December 29, 2025

CONTRACT NO. 1797

OHIO RIVER TUNNEL

ADDENDUM No. 11

Utility Inspection Coverage Exhibits

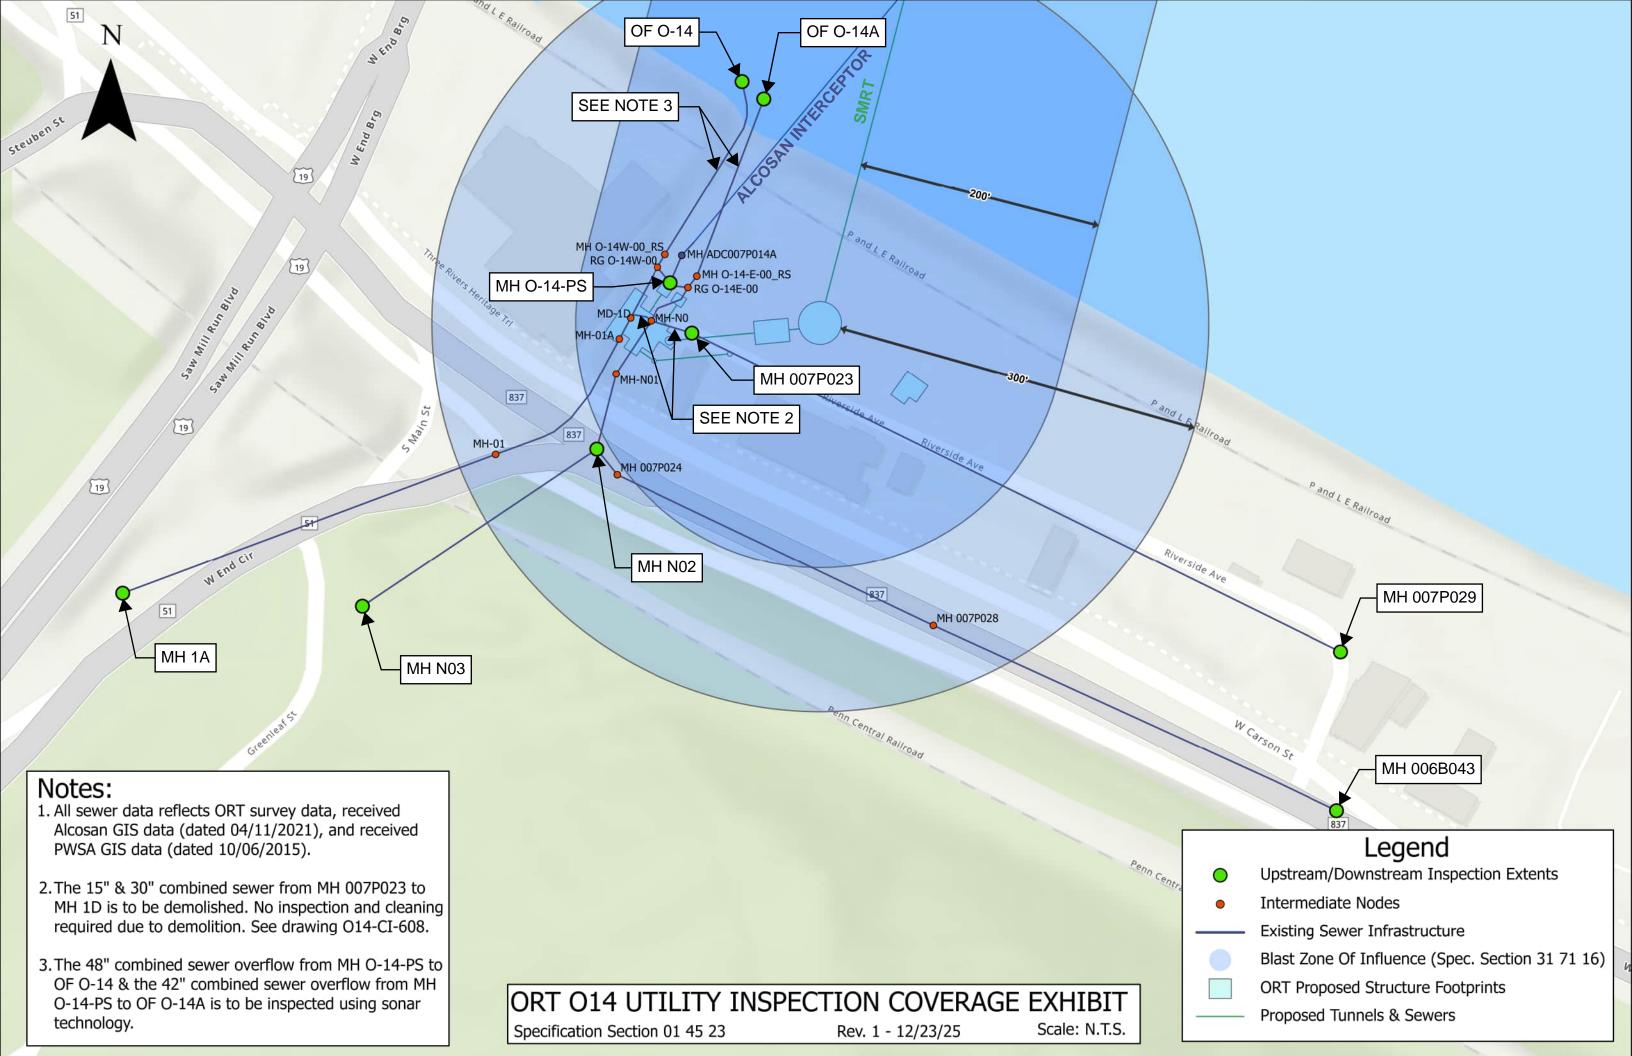
Q4 Attachment 2 from Specification 01 45 23, in the section for site O14, lists the cleaning and inspection of a 15" VCP and 30" RCP from MH 007P029 to MH 1D. The Utility Inspection Limit Map provided with Addendum 4 appears to show the 15" passing through MH 007P023 and into MH-N0 and, apparently, the 30" running from MH-N0 to MH1D. Drawing O14-CI-608 appears to show a different routing. The 15" appears to dead-end into the 42" RCP and the 30" appears to run from MH-N0 to a dead-end into the 48" RCP. Several questions arise:

- A) Refer to O14-CI-600 for the presumed routing of the sewer line based on field survey and CCTV inspection documentation. This information generally aligns with the Utility Inspection Coverage Exhibits included in Addendum 4, Attachment B.
 - B) Bidders to assume that the existing 15" and the existing 30" sewer lines may be influenced during dry weather.
 - C) Suggestion accepted. Replace Specification Section 01 45 23, Attachment 2 in its entirety with Specification Section 01 45 23, Attachment 2 REVISED 12/23/25. See Item 4 and Attachment A of this Addendum for CHANGES TO CONTRACT DOCUMENTS. Exhibits added to APPENDIX E –

SUPPLEMENTAL INFORMATION in Addendum 4 have been REVISED. See Attachment B of this Addendum.

- Revised O14-CI-600 (Sheet 519 of 770)
- Revised O14-ST-605 (Sheet 545 of 770)
- Revised O14-ST-606 (Sheet 546 of 770)

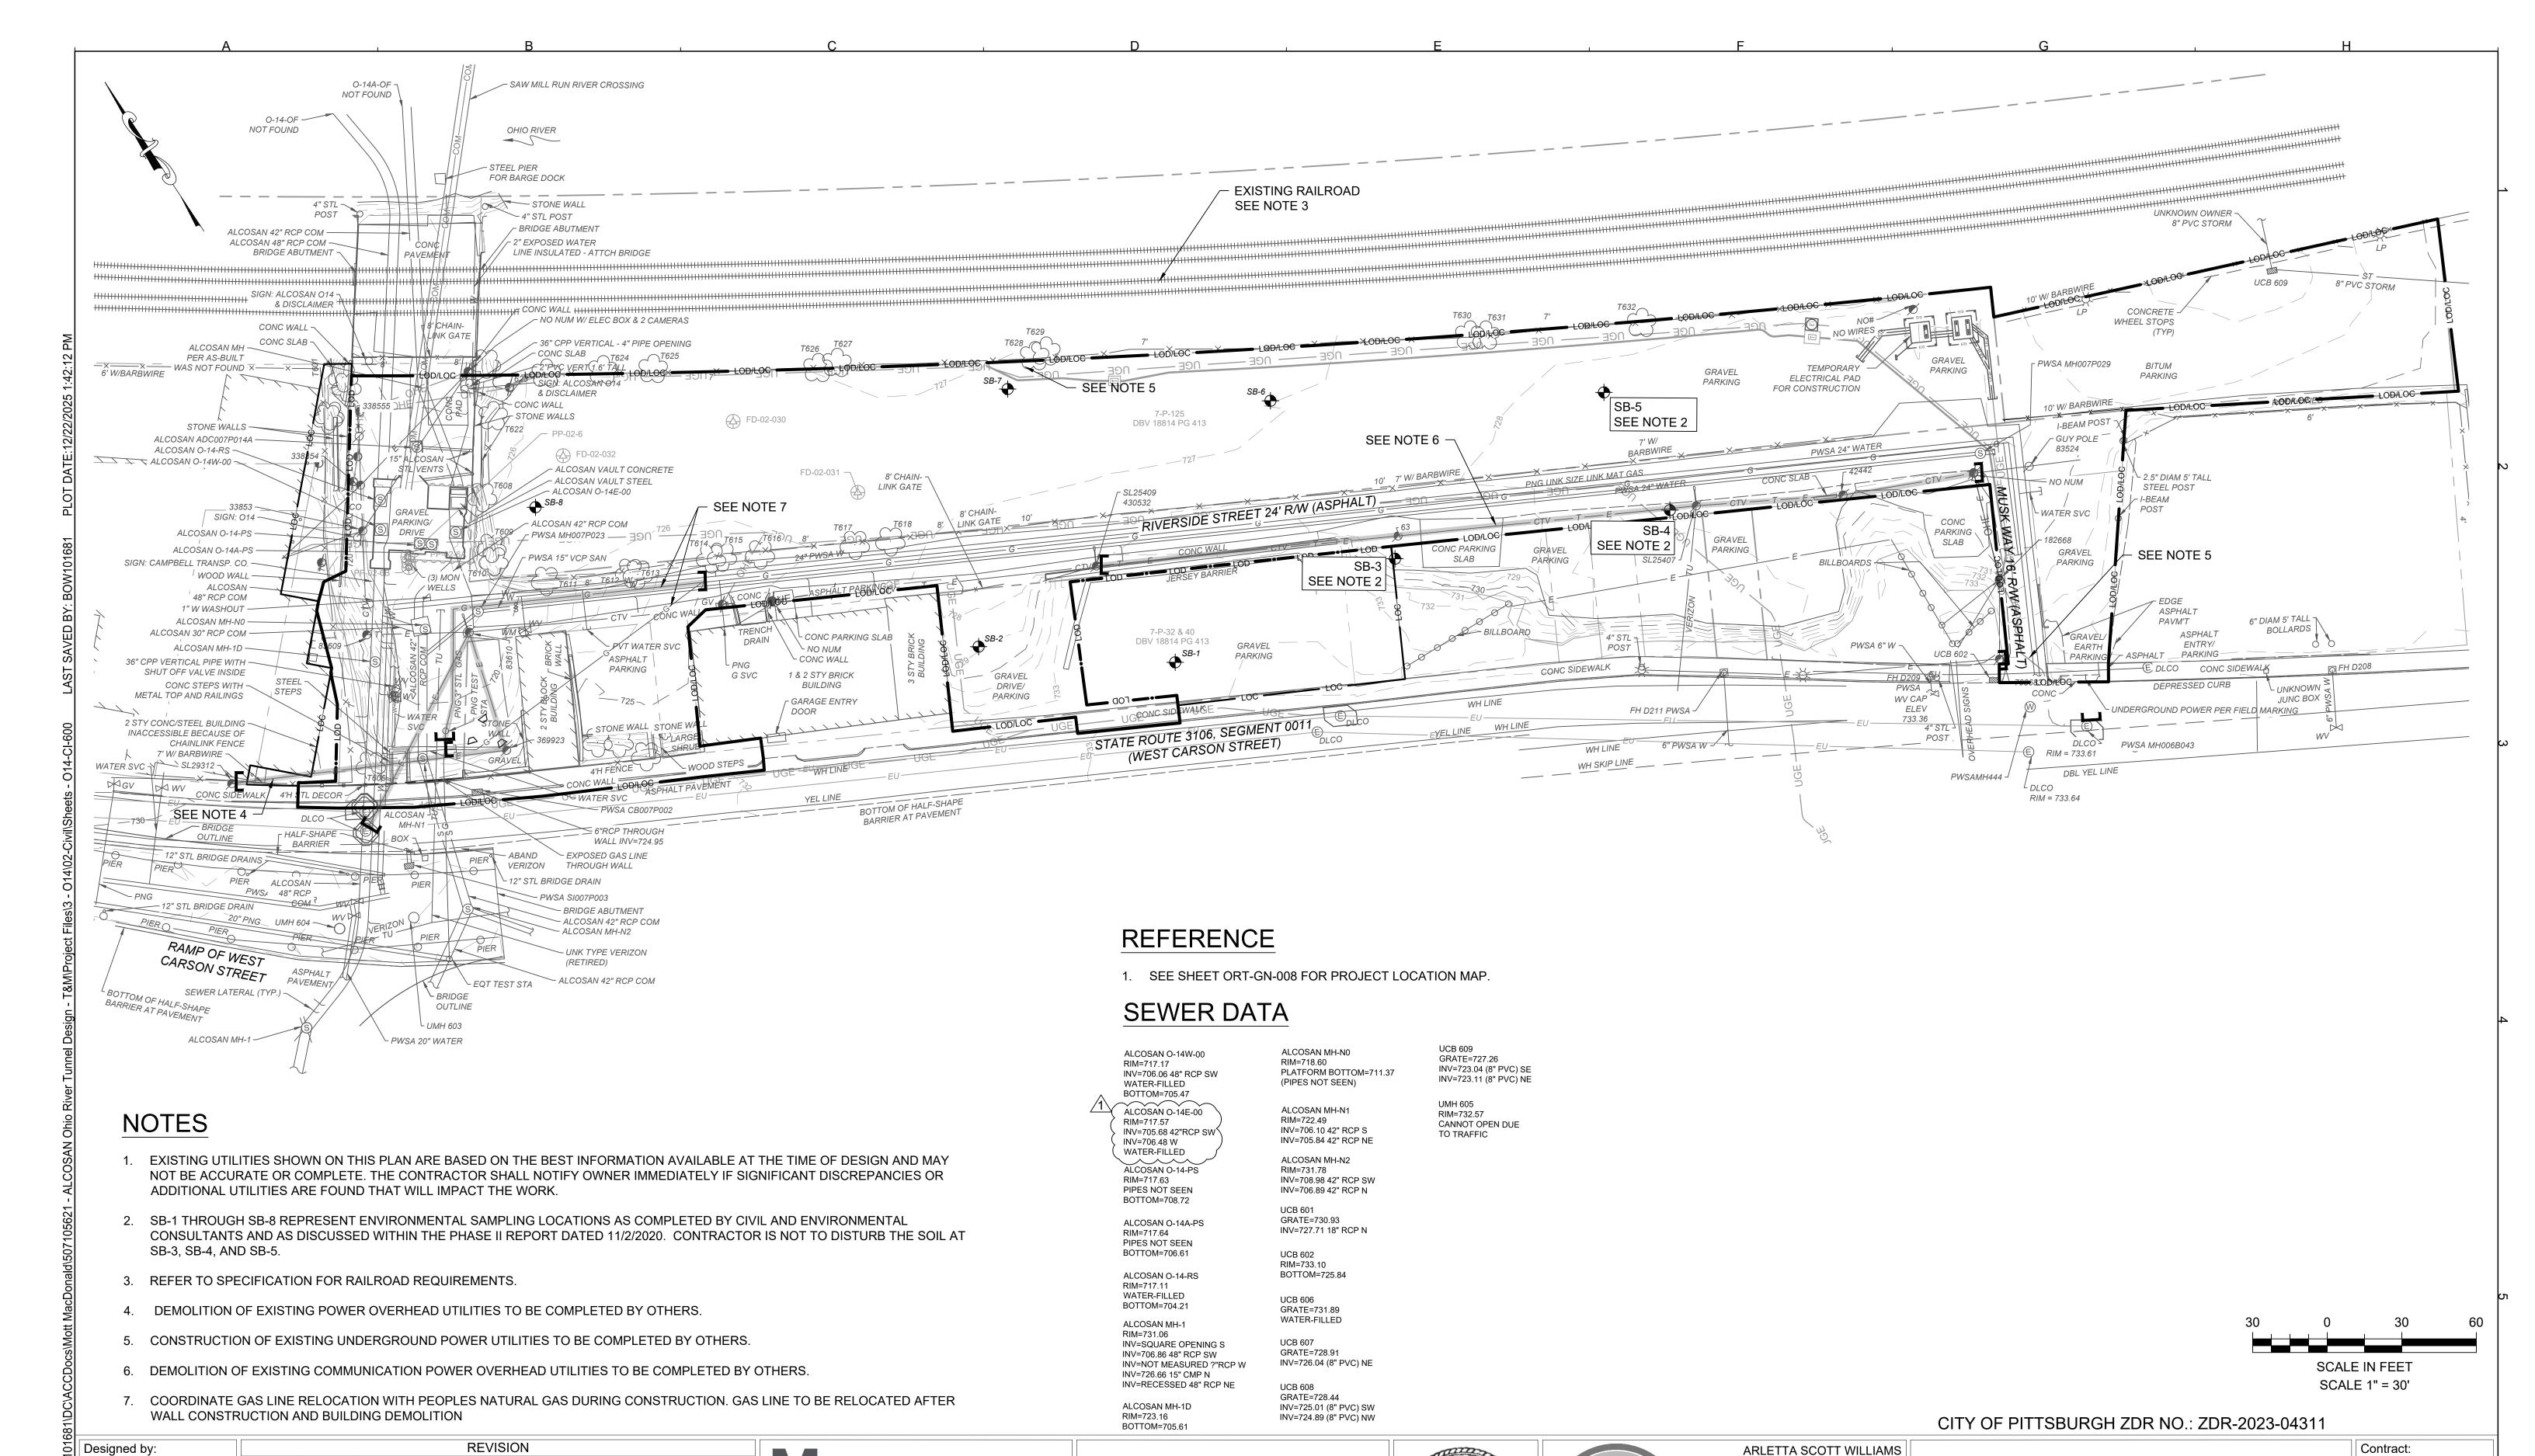
A7 Refer to Section 31 23 19 - Control of Groundwater and Construction Water, Part 1.8.A (Table) for the designations, and Sheet O14-CI-600, for the plan locations, of the proposed discharge points (ALCOSAN-O14W/O14E) into the existing O-14 Regulator.
